## LOST CREEK ISR, LLC

**Re: Lost Creek Project, NRC License SUA-1598, Docket No. 40-9068  
REQUEST FOR ADDITIONAL INFORMATION - AMENDMENT APPLICATION FOR  
INCLUSION OF YELLOWCAKE VACUUM DRYING-LOST CREEK ISR, LLC; (June 27, 2012)**

**Lost Creek Project, NRC License SUA-1598, Docket No. 40-9068; July 27, 2012**  
**REQUEST FOR ADDITIONAL INFORMATION-AMENDMENT APPLICATION FOR INCLUSION OF**  
**YELLOWCAKE VACUUM DRYING-LOST CREEK ISR, LLC; (June 27, 2012)**

Figure 1.7-2  
Lost Creek Project Development, Production and Restoration Schedule

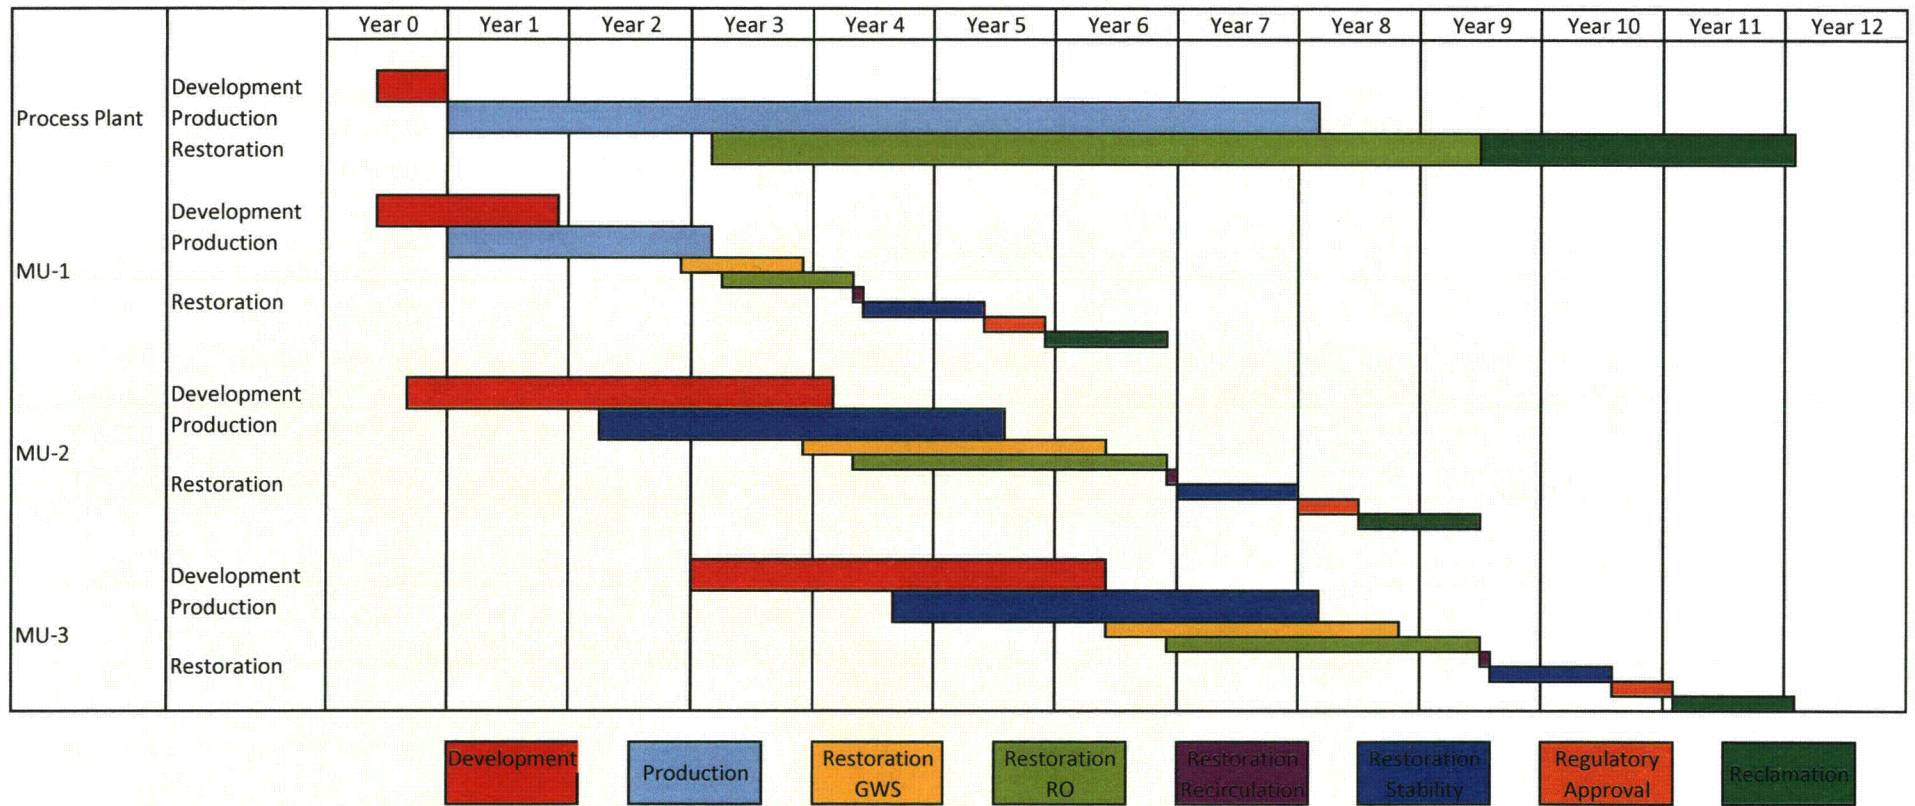
**Is the schedule (Figure 1.7-2 of technical report) current? If not, please provide a revised schedule to ensure compliance with 10 CFR 40.32.**

Please find attached a revised Figure 1.7-2 entitled "Lost Creek Development, Production and Restoration Schedule." While the schedule did not change, the number of total mine units was condensed from six (6) to three (3) pursuant to a request from the Wyoming Department of Environmental Quality – Land Quality Division. The total area and timing of the disturbance have not changed; only the names of the affected areas.

This schedule is provided as an alternate schedule as required in 10 CFR 40.42(f) since reclamation cannot be completed within the time limitation described in 10 CFR 40.42(d).

Figure 3.3-1  
Dryer Flow Diagram  
Lost Creek Permit Area

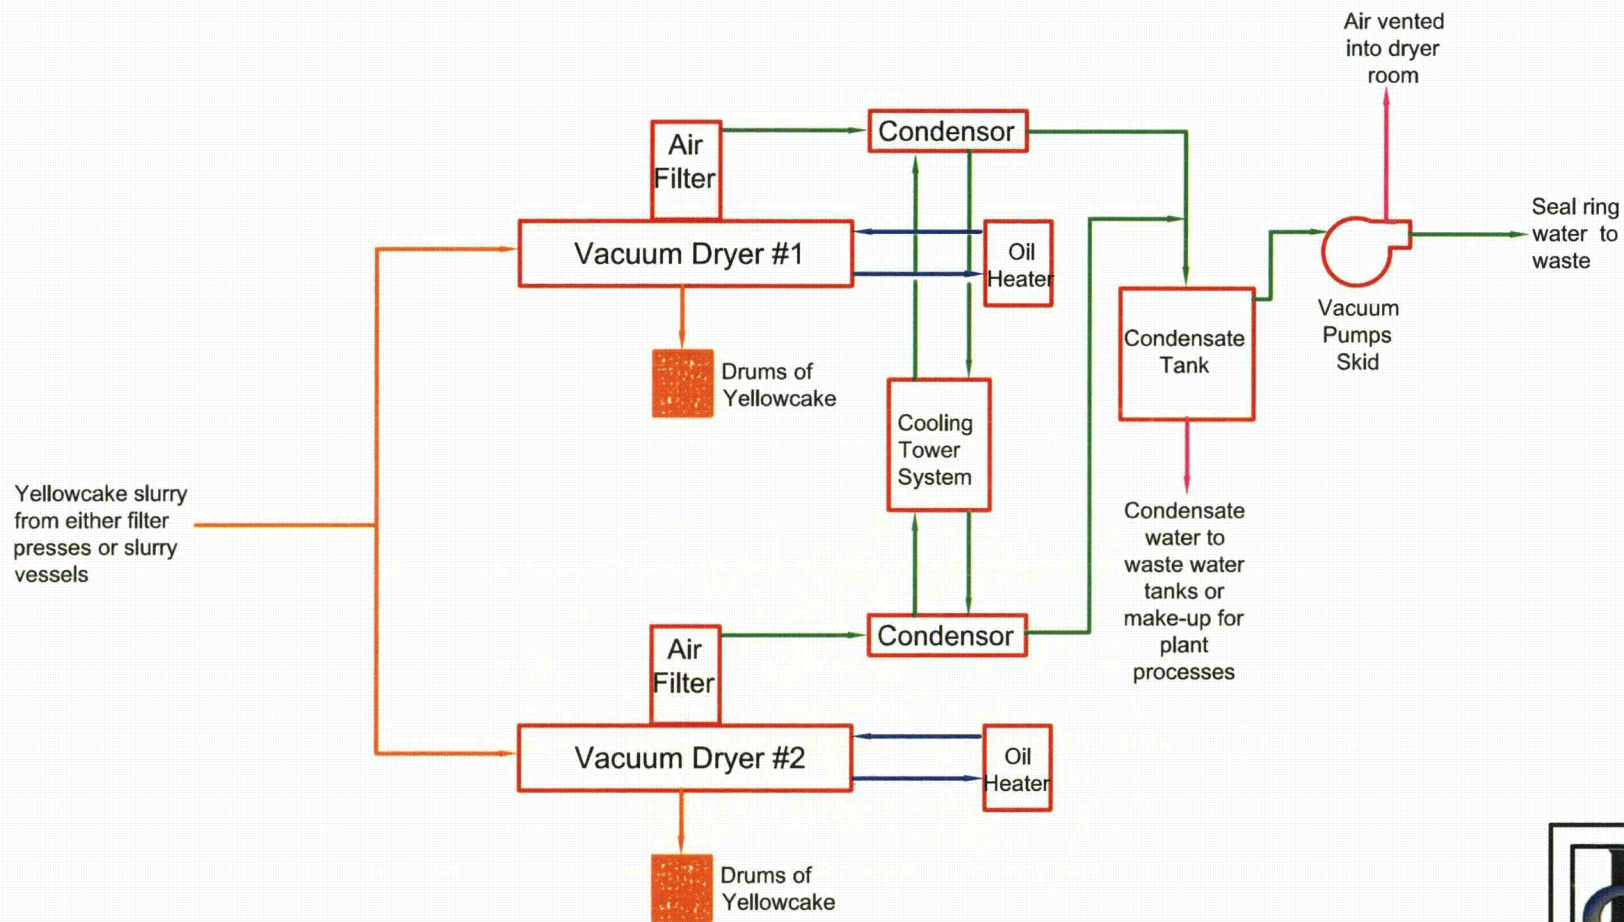
LCI did not number the diagram consistently as the other figures and plates in the TR and ER. Therefore, the staff requests that LCI label the diagram with the appropriate number (i.e., Figure 3.3-1) for easy identification.

Please find attached the "Supplemental Dryer Flow Diagram" labeled as "Figure 3.3-1," "Dryer Flow Diagram".
